AEP:NRC:1024E

Donald C. Cook Nuclear Plant Units 1 and 2
Docket Nos. 50-315 and 50-316
License Nos. DPR-58 and DPR-74
SAFETY INJECTION CROSS-TIE: RESPONSE TO NRC QUESTIONS
ON SMALL-BREAK LOCA ANALYSES FOR UNIT 2

February 29, 1988

LIMITING SMALL BREAK LOCA CONSIDERATIONS
FOR OPERATION OF DONALD C. COOK UNIT 2 WITH CLOSURE
OF THE HIGH HEAD SAFETY INJECTION CROSS-TIE

D. C. COOK UNIT 2
SAFETY INJECTION FLOW VS BREAK FLOW

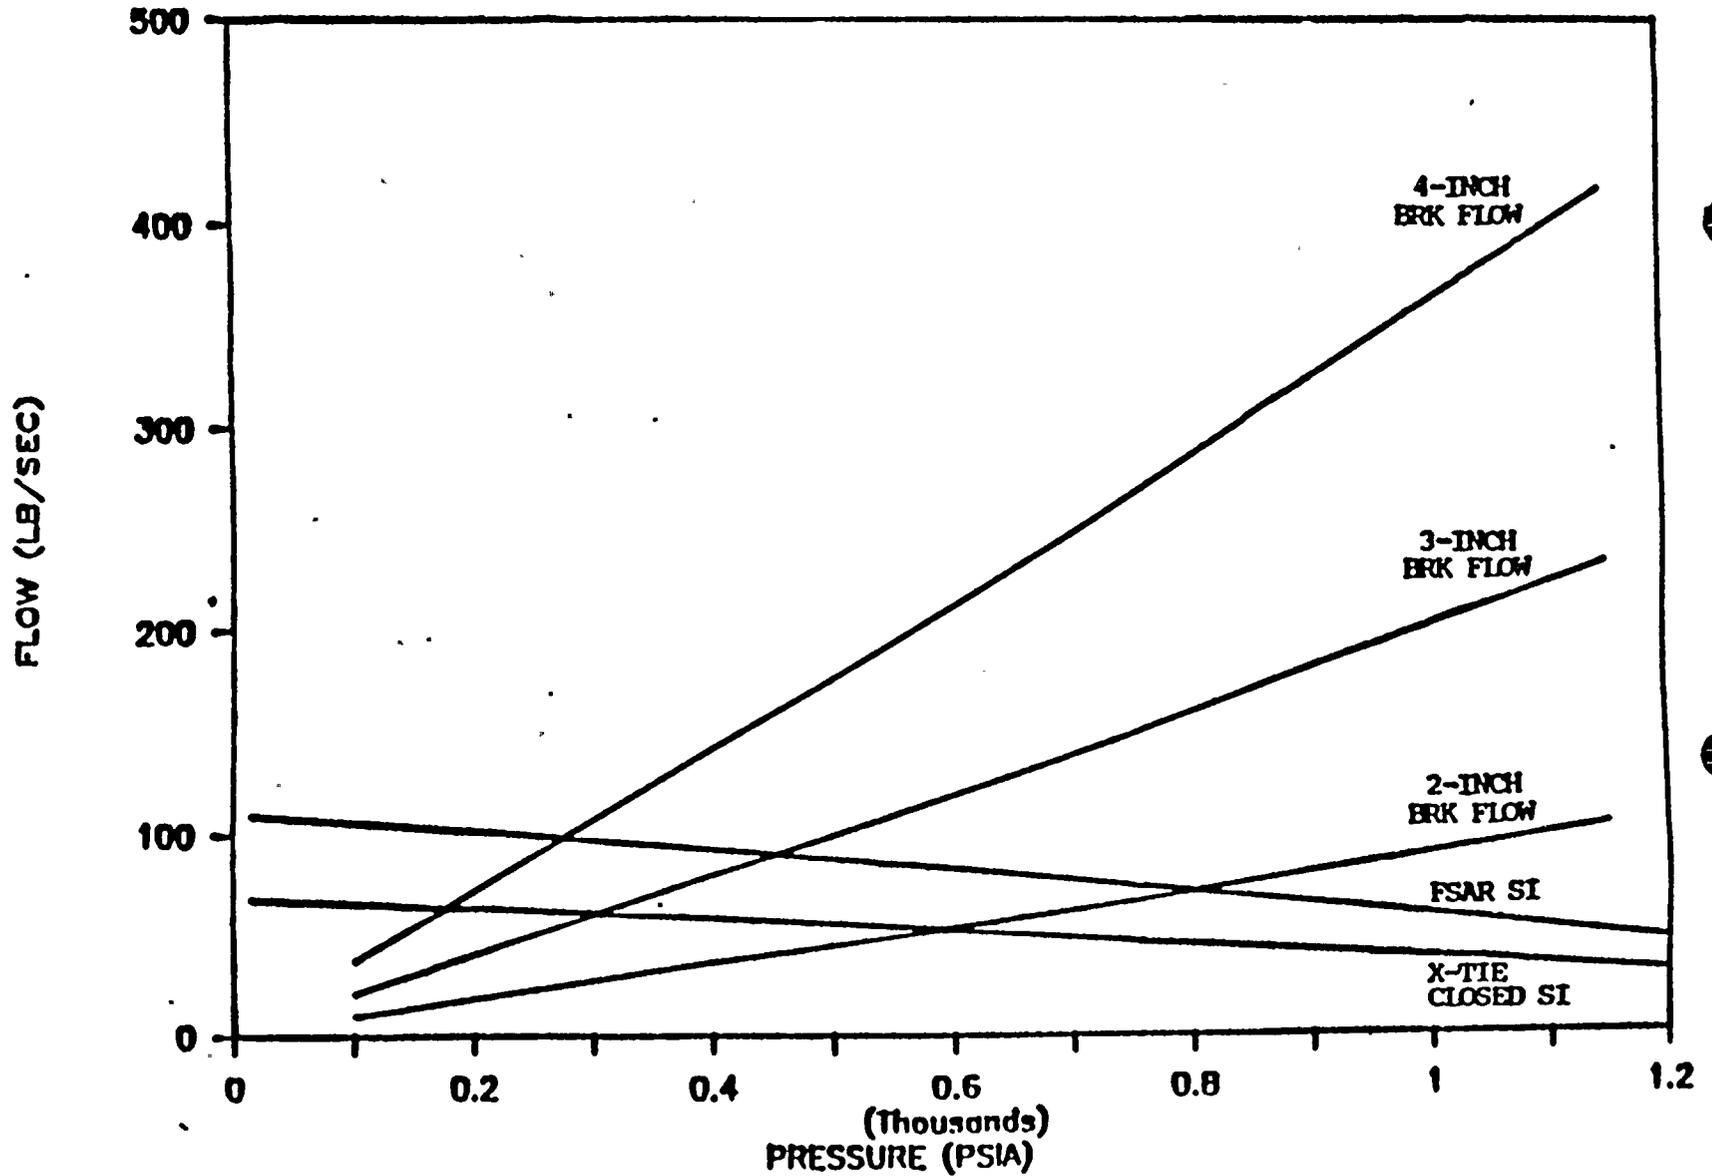
previously, in the event of a small break LOCA, the RCS pressure tends to reach equilibrium where pumped safety injection flow equals the break flow. Figure 1 shows a conservative estimate of the RCS pressure equilibration point for Donald C. Cook Unit 2 in the event of a 4-inch, 3-inch and 2-inch diameter break for both the current licensing basis safety injection flow and the safety injection flow available when the HHSI cross-tie is closed. The break flow rates are conservatively estimated for saturated steam. The 2-inch diameter break is expected to equilibrate at or above the Donald C. Cook Unit 2 minimum accumulator setpoint pressure of 600 psia when the HHSI cross-tie is closed. Therefore, recovery from RCS inventory depletion transient for the 2-inch diameter break should be dependent upon safety injection flow delivery alone.
